# Access Compliance Report

## Public Rights-of-Way

### (Curb Ramps)

Intersection ID: 4677	Main Street: OLD_STATESVILLE_RD	Cross Street: HENDERSON_RD	Location: E
ADA ID: 492E78E1F73C	Ramp Type: Perp	Initial Pass/Fail: Fail	Overall Compliance: No
Severity Score: 33.75			
Codes/Mitigation Info/Possible Solution		Field Measurements/Component Compliance

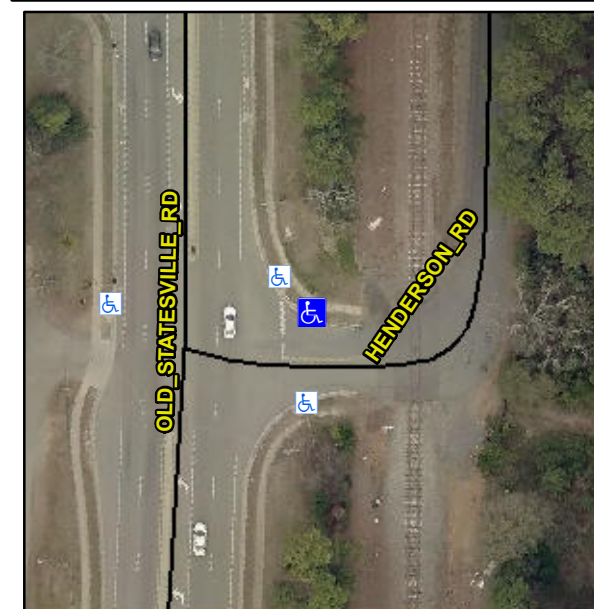
**Not Found, R304.5.1, R304.2.2**

Compliance	Description	Data	Compliance	Description	Data
N/A	Ramp Length (in)	59.0	No	Ramp Slope (%)	13.3
No	Ramp Width (in)	46.0	Yes	Ramp XSlope (%)	0.4
N/A	Flare Type LT	N/A	N/A	Flare Type RT	N/A
N/A	Flare Slope LT (%)	N/A	N/A	Flare Slope RT (%)	N/A
N/A	Flare Traversable LT?	N/A	N/A	Flare Traversable RT?	N/A
N/A	Landing Length (in)	N/A	N/A	DWS Provided?	N/A
N/A	Landing Width (in)	N/A	N/A	DWS Contrast?	N/A
N/A	Landing Slope (%)	N/A	N/A	DWS Length (in)	N/A
N/A	Landing X Slope (%)	N/A	N/A	DWS Full Width?	N/A
N/A	Landing Curb? (Y/N)	N/A	N/A	DWS Offset (in)	N/A
N/A	Shared Landing?	N/A			
N/A	Gutter Ponding?	N/A	N/A	Gutter Slope (%)	N/A
N/A	Gutter Lip Ht (in)	N/A	N/A	Gutter X Slope (%)	N/A
N/A	Painted X Walk1?	No	N/A	Painted X Walk2?	N/A
	X Walk 1 Direction	To S		X Walk 2 Direction	N/A
N/A	X Walk 1 Width (in)	N/A	N/A	X Walk 2 Width (in)	N/A
	X Walk 1 Slope (%)	2.1		X Walk 2 Slope (%)	N/A
	X Walk 1 X Slope (%)	0.0		X Walk 2 X Slope (%)	N/A

**Remove & Replace Entire Ramp.**
